City of Tarpon Springs, Florida

Heritage Preservation Board
324 East Pine Street
Tarpon Spring, Florida 34689
(727) 938-3711

**REGULAR SESSION AGENDA
MONDAY, JUNE 1, 2026
6:30 PM - CITY HALL AUDITORIUM**

- a. 26.38 Hoffman - Certificate of Approval for new kitchen, bathroom and garage - 184 N. Spring Blvd
- b. 26.40 Locatelli - Certificate of Approval for new build garage and storage structure - 116 N. Pinellas Ave
- c. 26.43 McClain - Certificate of Approval for single family new build - 305 Bath St

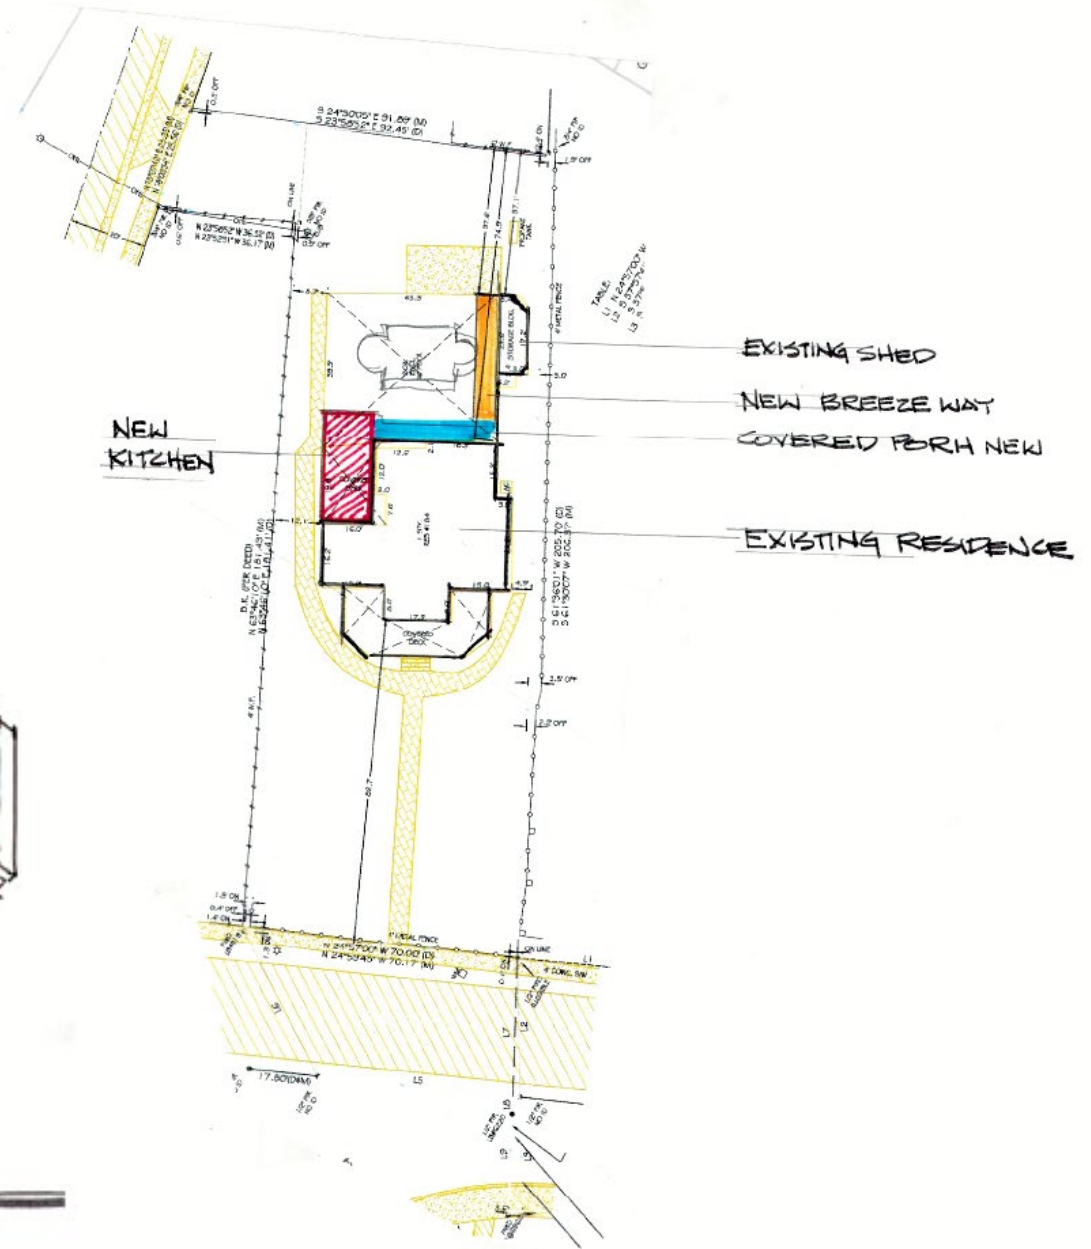
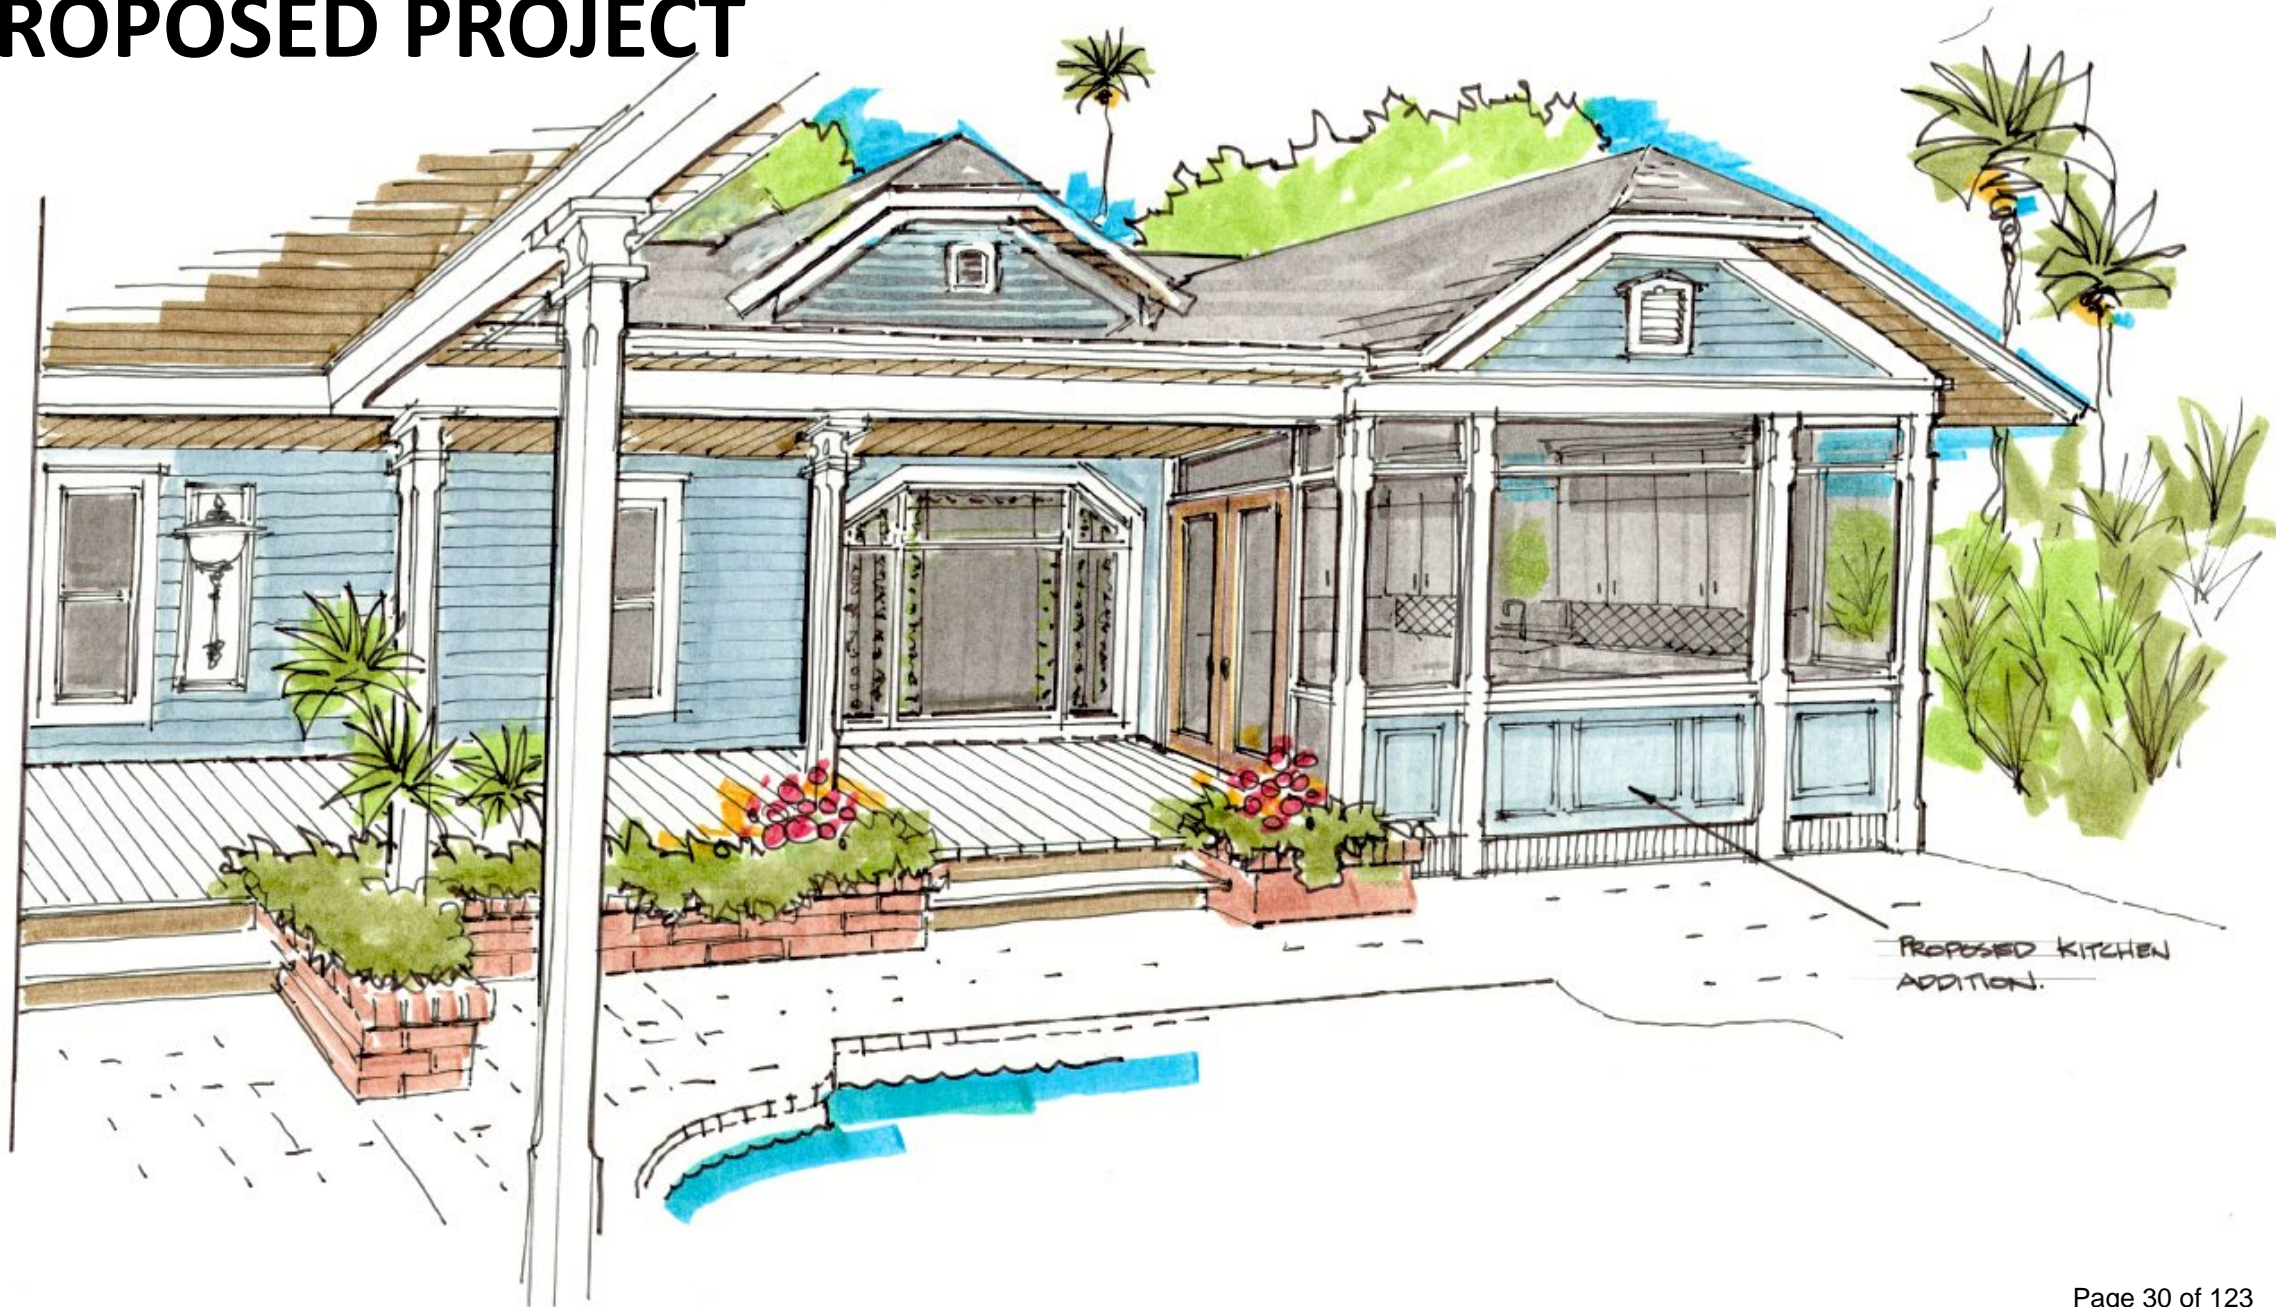
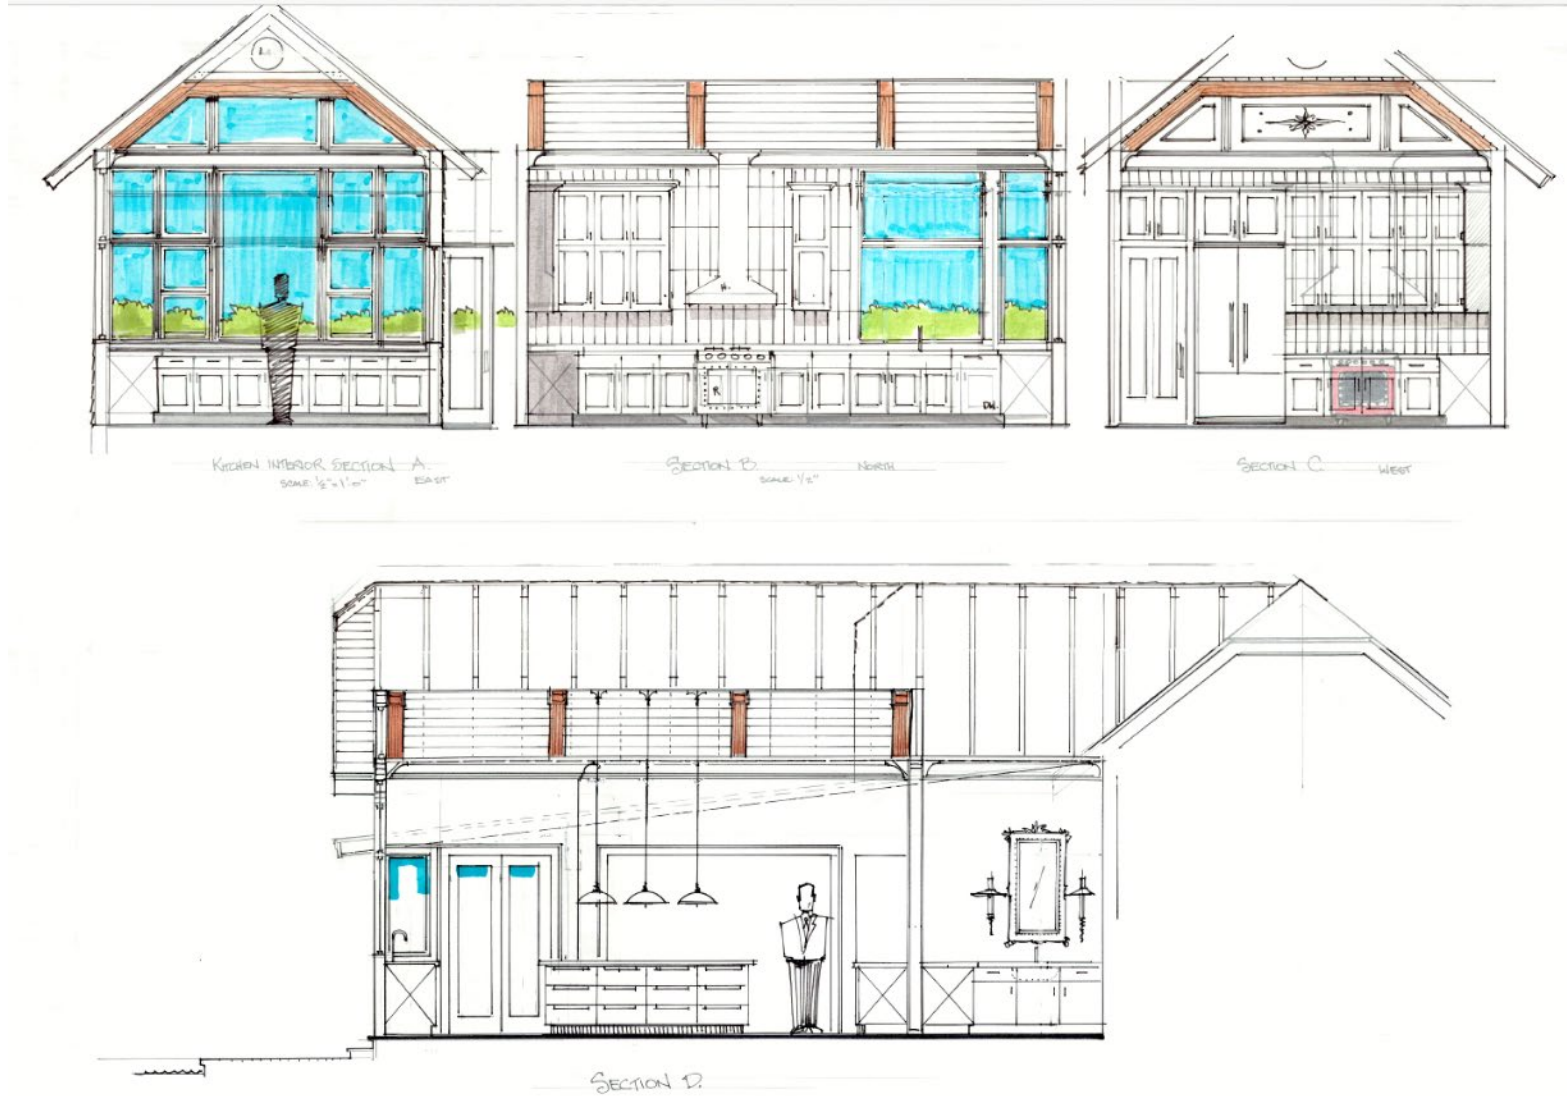
The applicant is seeking a Certificate of Appropriateness (CA) to renovate an existing rear porch addition under roof into a kitchen (approximately 14’ x 30’), construct a new single-story covered porch (8’ x 28’), reroof and add a roof addition to an existing circa 1920’s contributing shed, construct a single-story breezeway between the existing shed and the new porch, and construct a two-story detached garage (22’ x 22’) on the subject property.

The height and width of the proposed new two-story garage appears to be generally consistent with adjacent contributing structures and similar Folk Victorian and Frame Vernacular structures in the immediate neighborhood and the local and National Register districts, although detailed site plan and specifications for the proposed structure have not been provided. The subject property is surrounded by two- and three-story structures, and the addition of a two-story detached garage is not anticipated to adversely impact the visual rhythm or character of the neighborhood. Any plans for a two-story detached garage approved by the HPB would need to meet district setbacks and height regulations, or seek a variance.

The setbacks for the proposed two-story garage appear to conform to district standards and are complimentary to other properties in the immediate vicinity. Any plans for the proposed two-story garage would need to conform with district standards and setbacks or seek a variance.

ANALYSIS: The kitchen addition, new patio, and breezeway conform with the Land Development Code and can be interpreted as balancing the goals, objectives, and policies of the Comprehensive Plan. The proposed two-story garage appears to conform to the Land Development Code and is generally consistent with the Comprehensive Plan. Any plans for the proposed two-story garage would need to conform with district standards and setbacks or seek a variance.

PROPOSED PROJECT

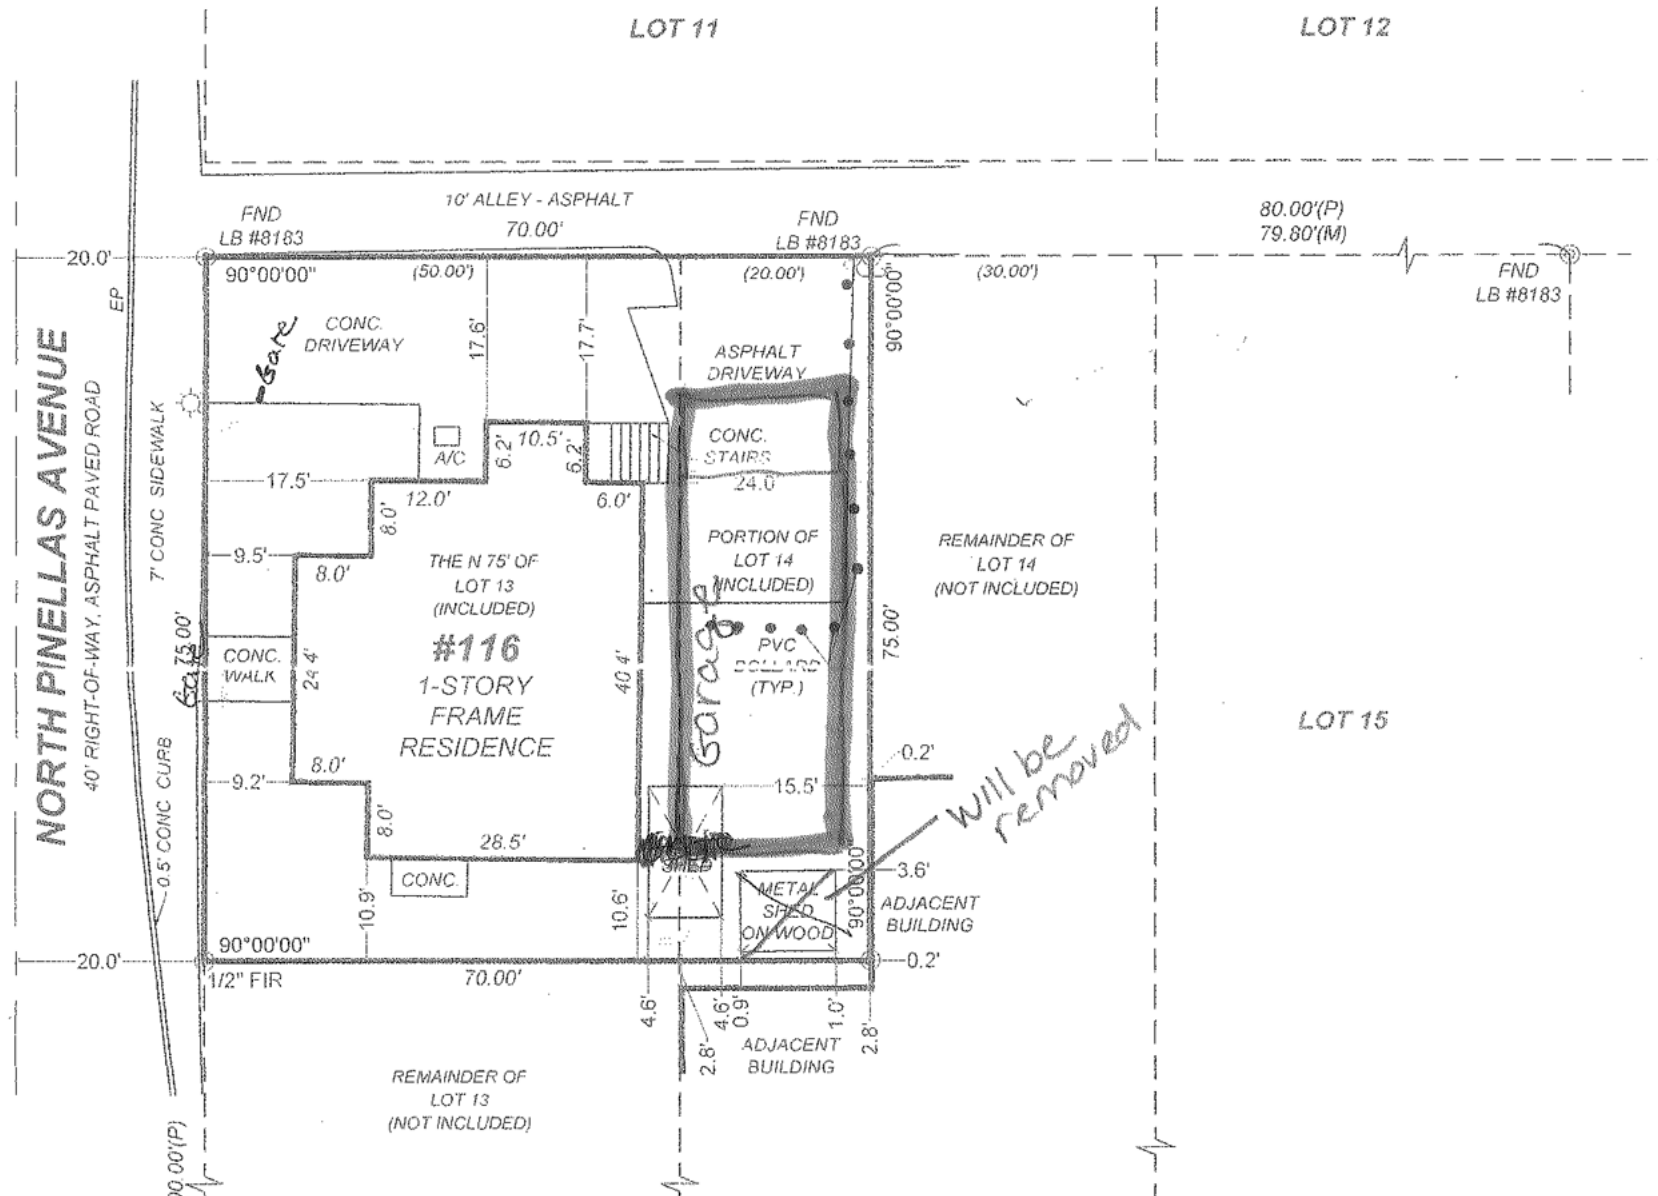
ANALYSIS: The proposed new building would alter the historic streetscape and change the relationship between open space and the street. The proposed setbacks for the property conform to district standards and are similar to other properties in the immediate vicinity.

1. The design will be revised to utilize a front gable roof.
2. Exterior siding will visually approximate the siding on the historic structure.
3. Architectural shingles will be used for the roof.
4. Carriage style doors will be utilized for the garage.
5. The Certificate of Appropriateness will expire in three (3) years if a building permit has not been issued for the project.

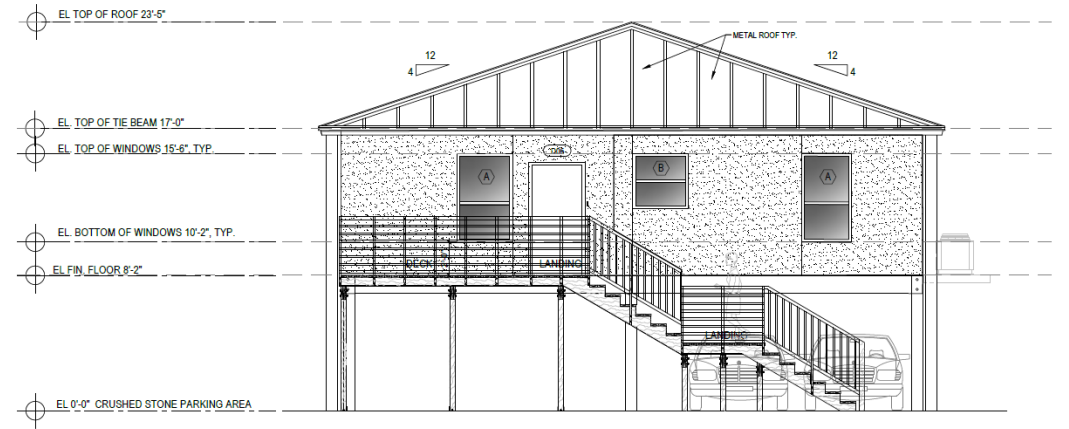
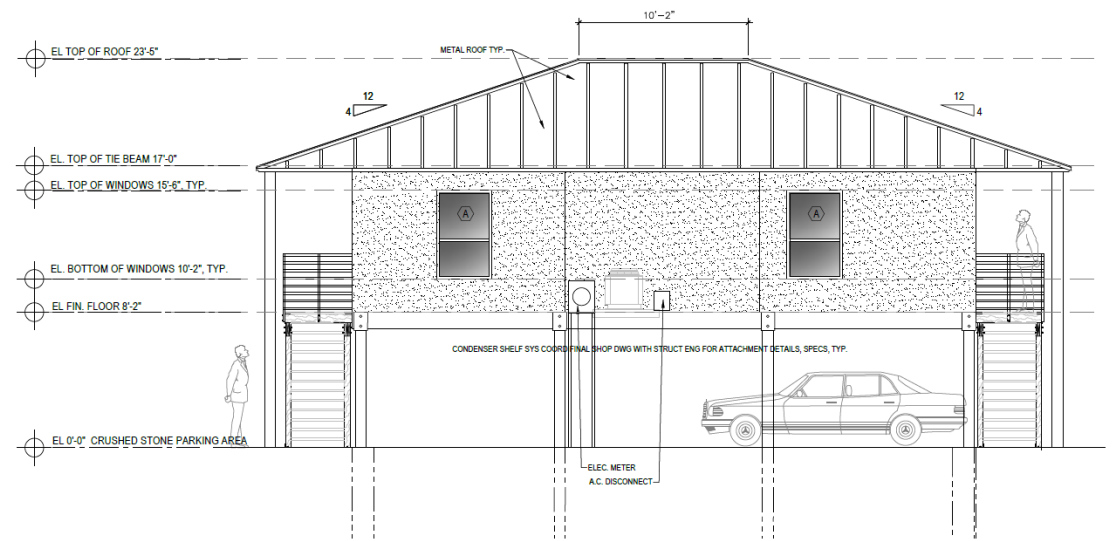
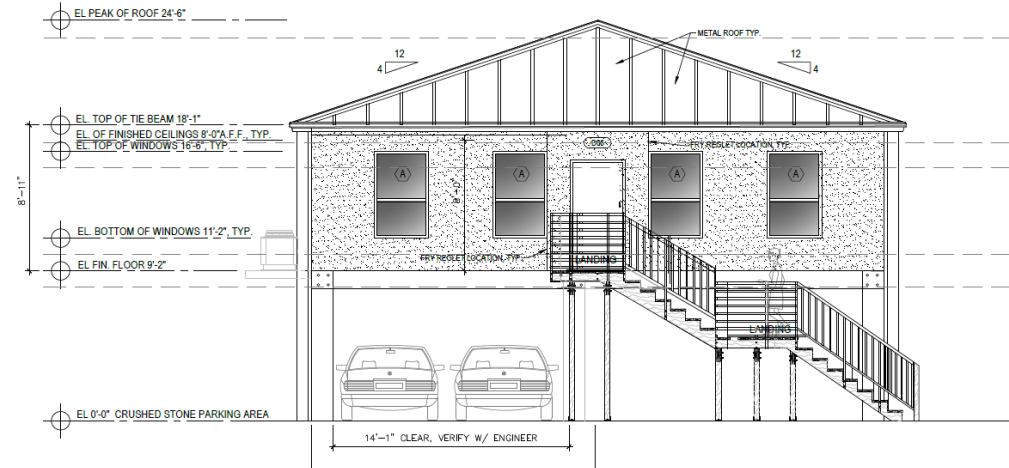
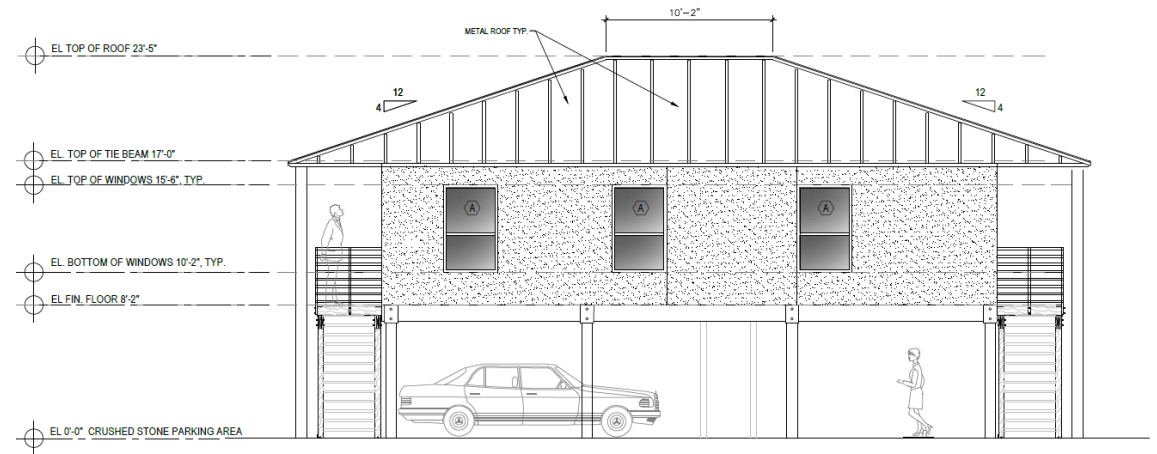
ANALYSIS: The proposed construction would alter the historic streetscape and change the relationship between open space and the street. The proposed setbacks for the property conform to district standards and are similar to other properties in the immediate vicinity.

ANALYSIS: A landscaping plan will need to be developed to conform with code requirements as part of the building permitting process.

ANALYSIS: The proposed project conforms with the Land Development Code and generally complies with the Comprehensive Plan.
